**RE: PART VIII – Renovation and Restructuring of the Tholsel Building
Planning & Development Acts 2000 – 2018
Planning & Development Regulations 2001 – 2018**

Chief Executives Report on the Consultation process
for the proposed
for the restructuring and renovation of
The Tholsel (City Hall)
High Street, Kilkenny.

May 2019

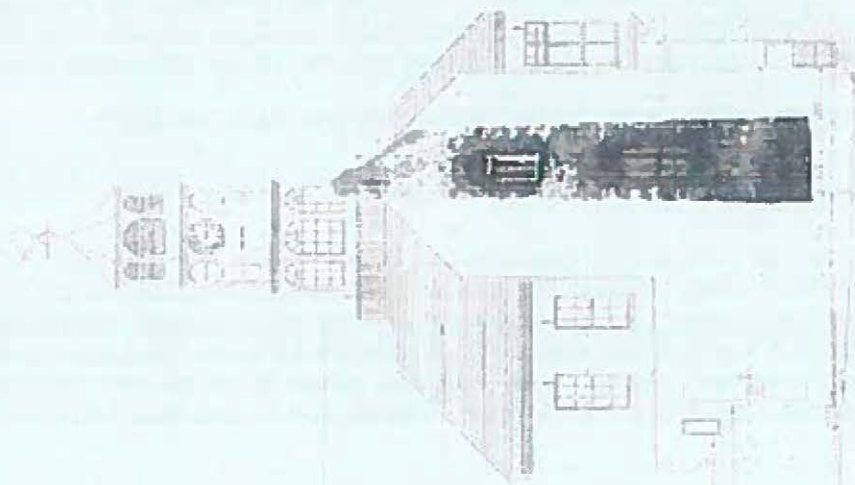
3. The glazed-and-wood reception and ticket office is incongruous inside an 18th c. medieval building on a busy street. The metal railings are a 1950s construct to counteract anti-social activities, but are surprisingly popular. This could be because the form a boundary to the raw street life from the quieter activities inside the rails.

4. The proposal to remove the clutter of disfiguring extensions at the rear of the building is very welcome. However the proposed large new east (rear) façade appears austere and obtrusive, especially as viewed from a distance such as Johns Quay and the new Butler Gallery. We strongly recommend that windows similar to the old windows (seen in the Crawford Collection photograph) be installed rather than the long continuous glazing proposed. Attached to this submission is an example of how it would look, using a superimposed clipped portion of the photograph. It restores the original elegant style to the façade. We also recommend that the wall be painted in a colour that harmonizes with the colour of the stone walls and slate roof. On balance we feel that the copper roof will age elegantly, rather like Rathmines Town Hall in Dublin, but there are mixed views on this.
